CITY OF RENTON

DEPARTMENT OF COMMUNITY AND ECONOMIC DEVELOPMENT REPORT TO THE HEARING EXAMINER

Project Name: 168 Development		Project Number: LUA15-000745, ECF, SHPL-A, SA-A, R, MOD, MOD		
Date of Meeting May 17, 2016	Staff Contact Clark H. Close Senior Planner	Project Applicant Steve Wu, 8822 NE 128th St, Bothell, WA 98011	Project Location 16826 108th Ave SE, Renton, WA 98055

DRAINAGE PLAN

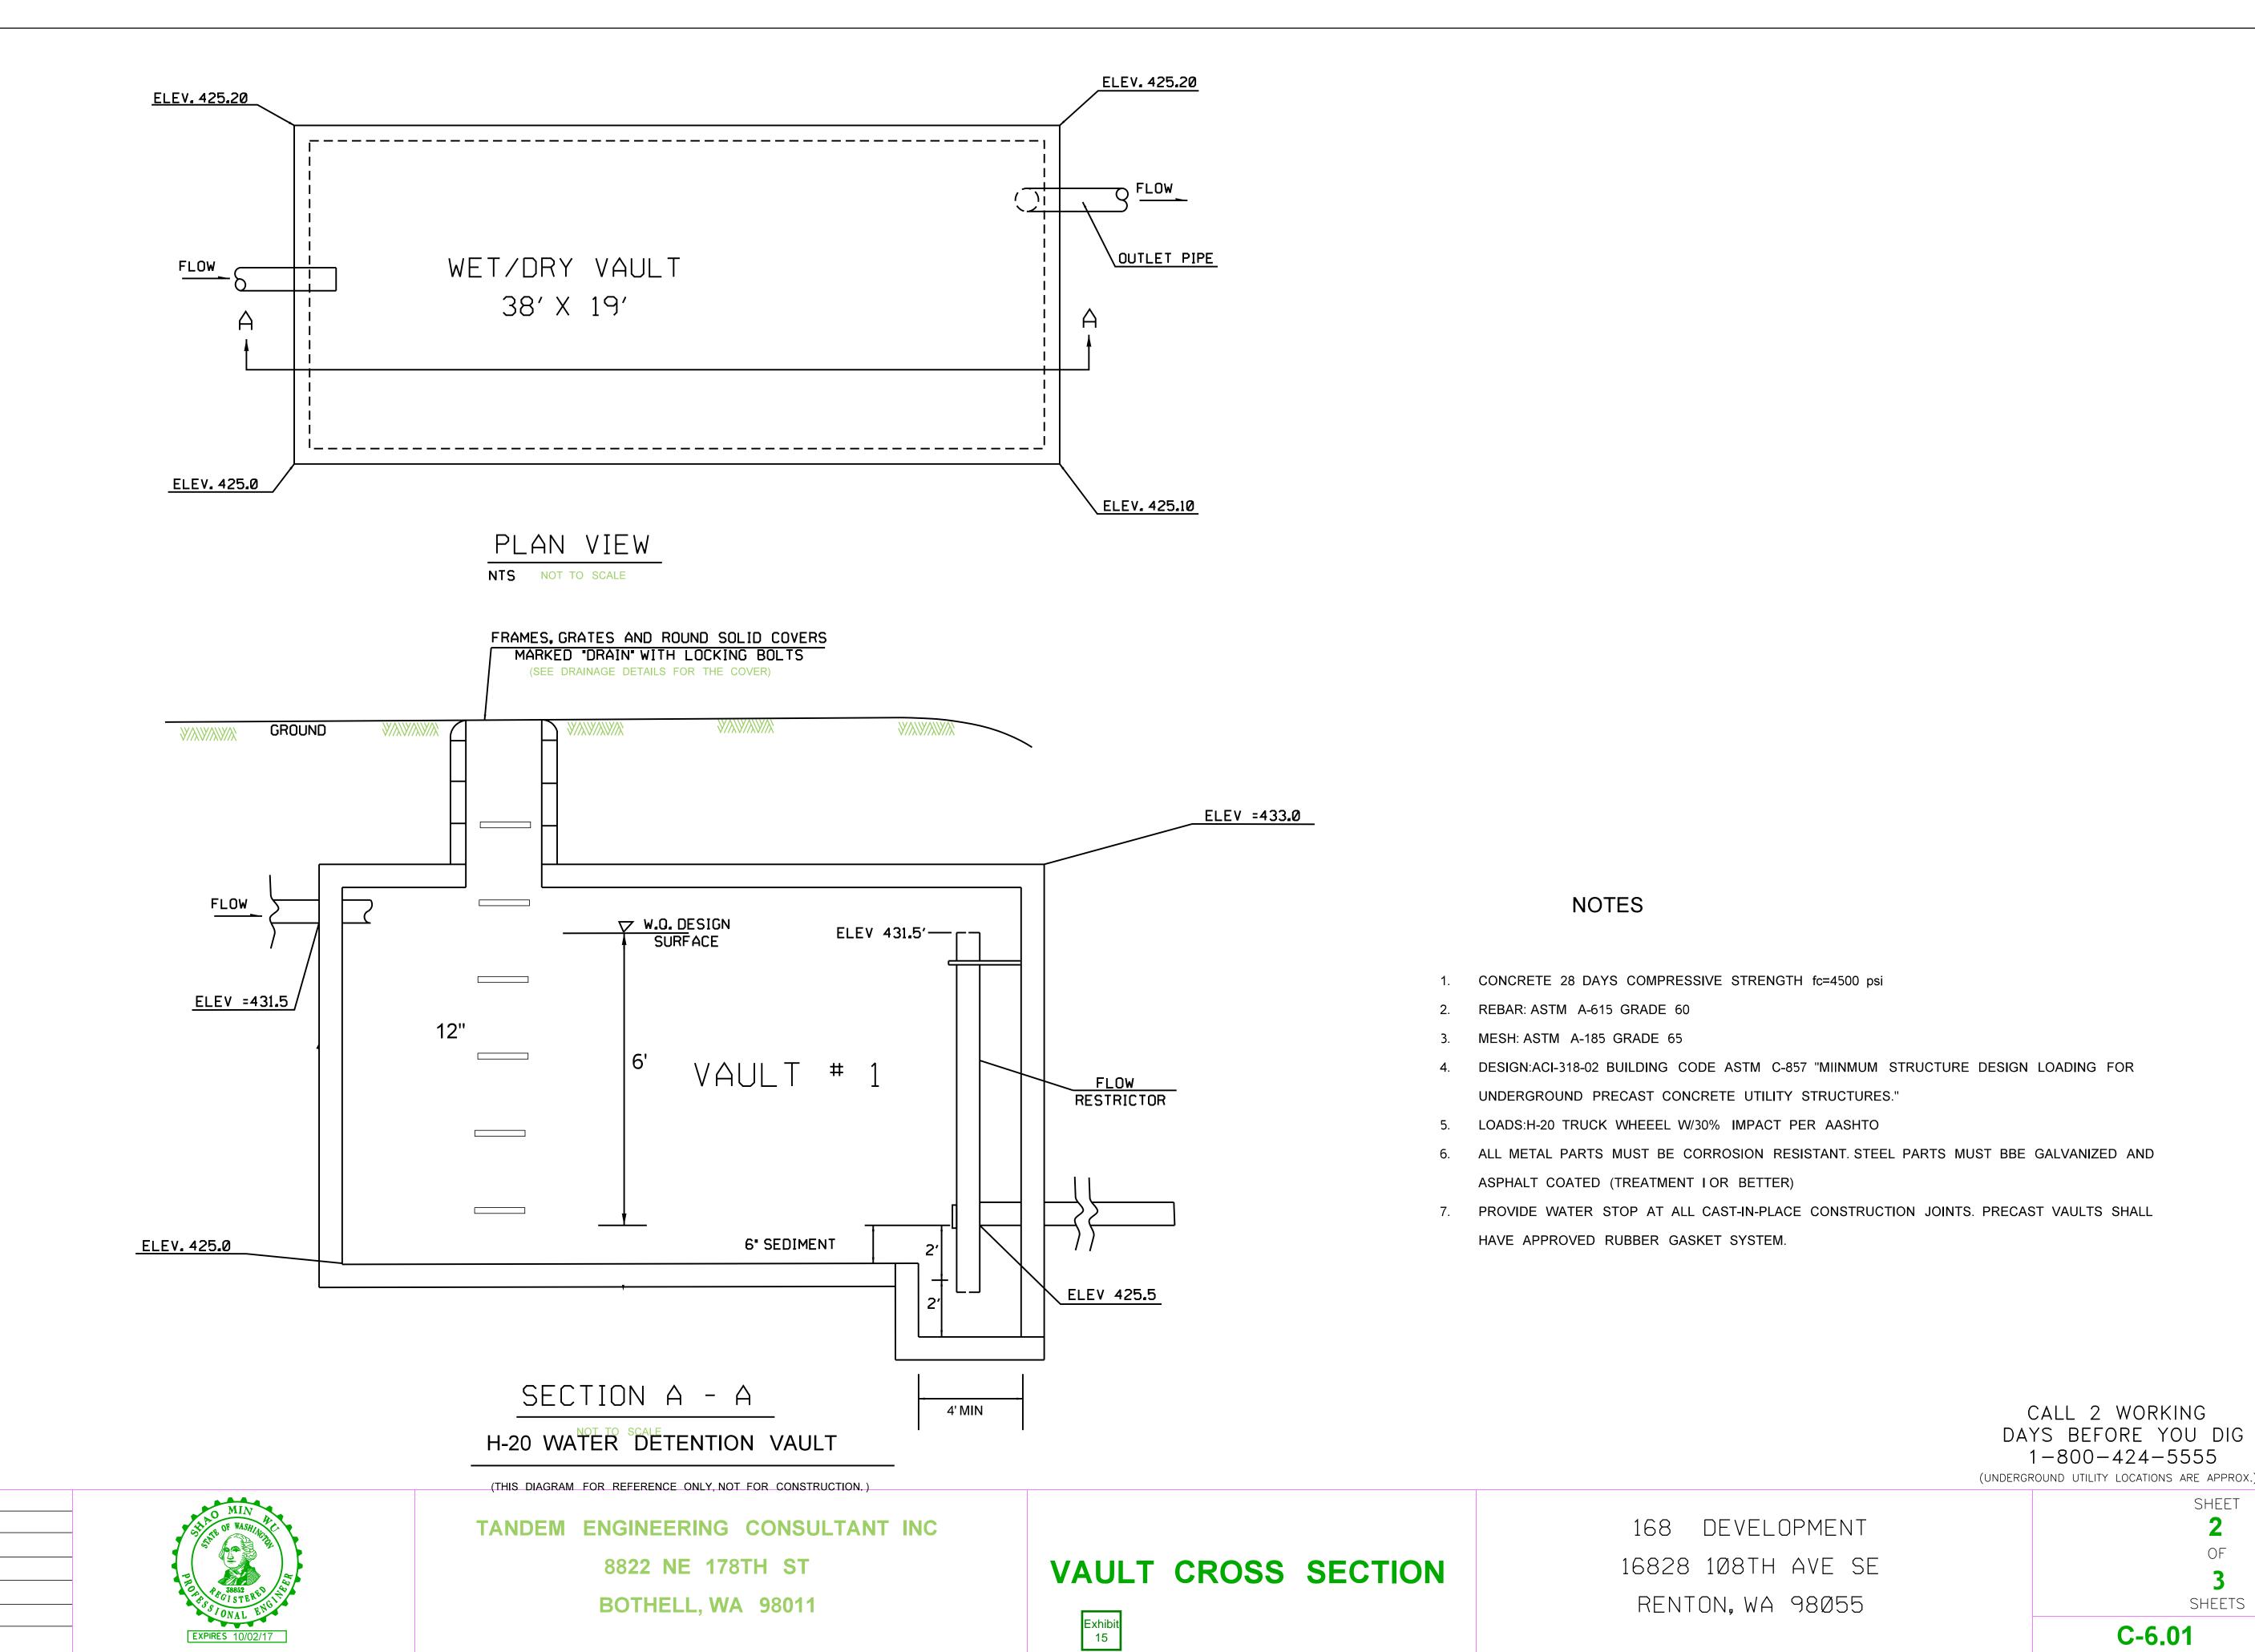
1. A Preliminary Drainage Plan and Technical Information Report (TIR) completed by Tandem Engineering Consultants were submitted to the City on October 9th, 2015. The site is approximately 0.75 acres in size and is located in the City's Flow Control Duration Standard (Forested Conditions). The site is located in the Black River drainage basin.

The project is proposing to detain surface runoff through two separate facilities. A detention vault (Vault #1) is proposed between the western two townhomes. This vault is intended to provide the required flow control for the impervious roofs of the townhomes. A combination detention / wetvault (Vault #2) is proposed under the access roadway south of the existing house and the westernmost townhome. This vault is intended to provide detention for the remainder of the parcel and Basic Water Quality for the pollution generating impervious surface. The site is graded to provide inflow to this vault at two grates at the western and eastern ends of the vault. The

Drainage improvements along the 108th Avenue SE frontage shall conform to the City's street standards. Storm drains should be located outside of the planter and the sidewalk. Required horizontal and vertical separation from other utilities shall be provided.

All core and special requirements shall be addressed in the updated TIR. The updated drainage plan and TIR will be required as part of the utility permit submittal.

TREE RETENTION / LAND CLEARING PLAN

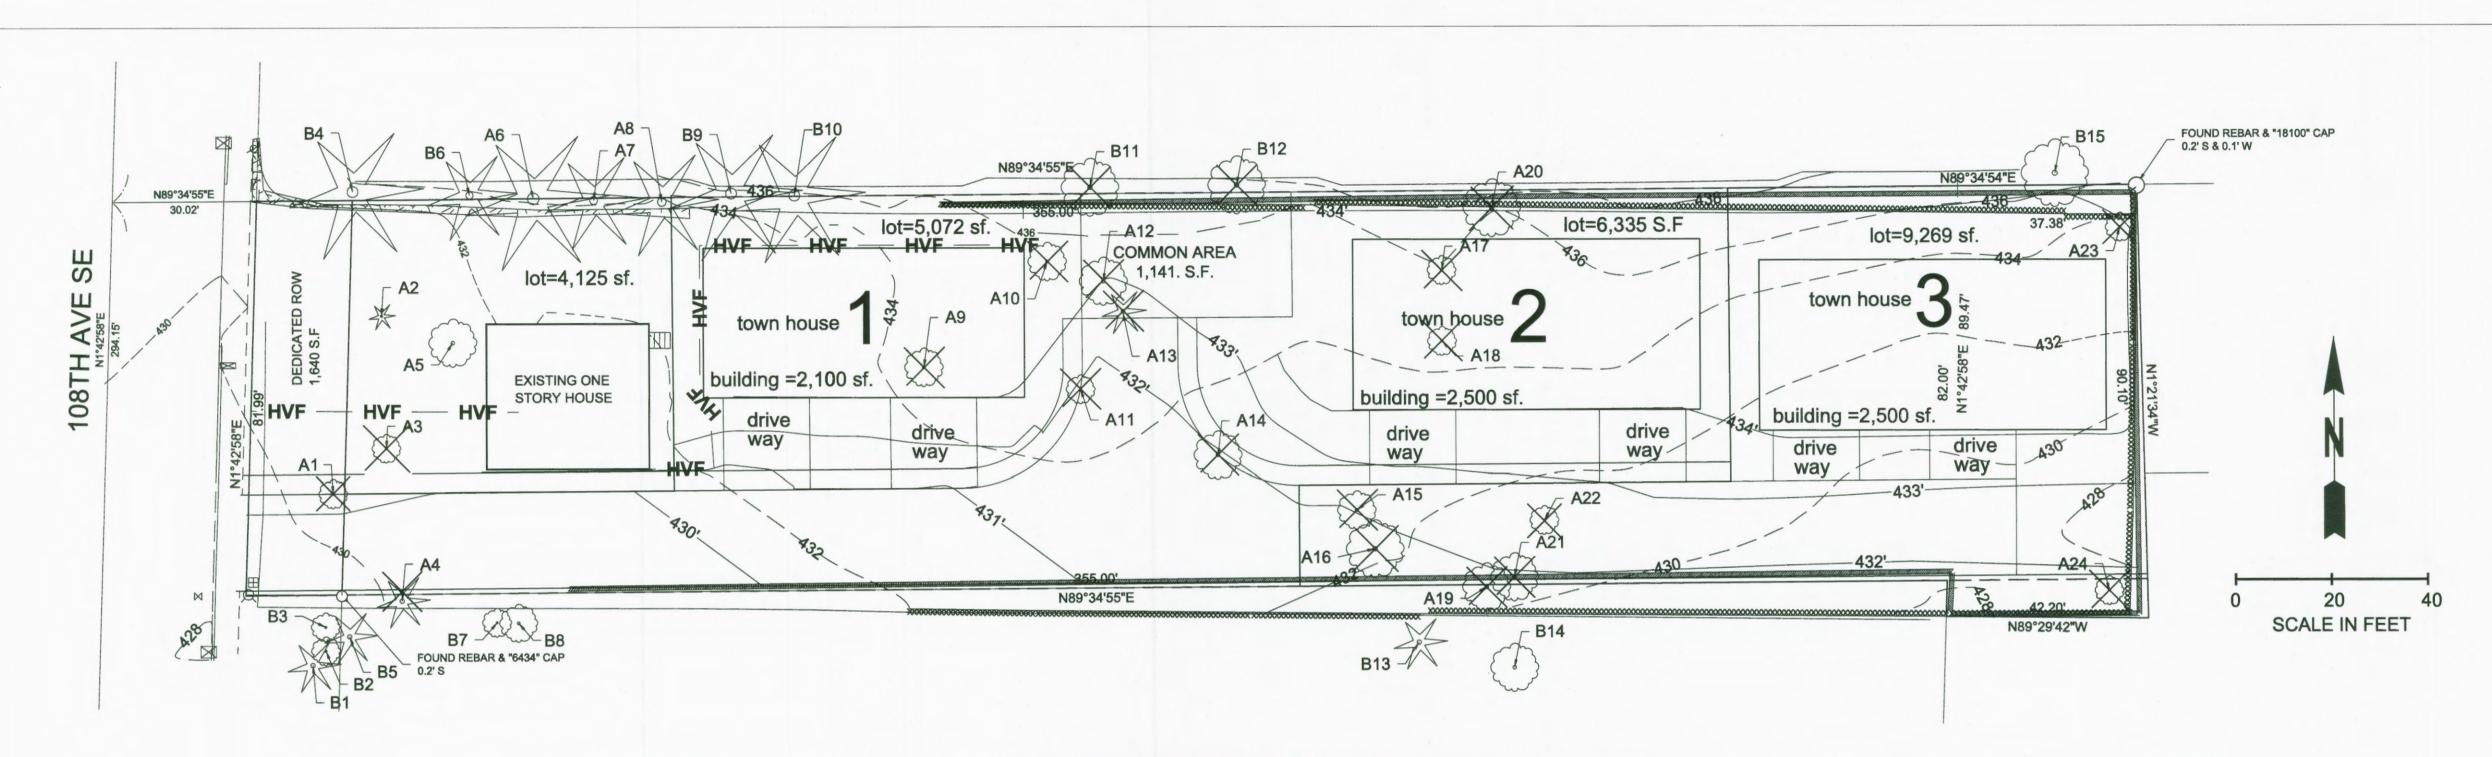
- 7. Structural plans for the storm drainage vaults shall be included with the civil plan submittal.
- 8. A final tree removal/retention plan and landscape plan shall be included with the civil plan submittal.
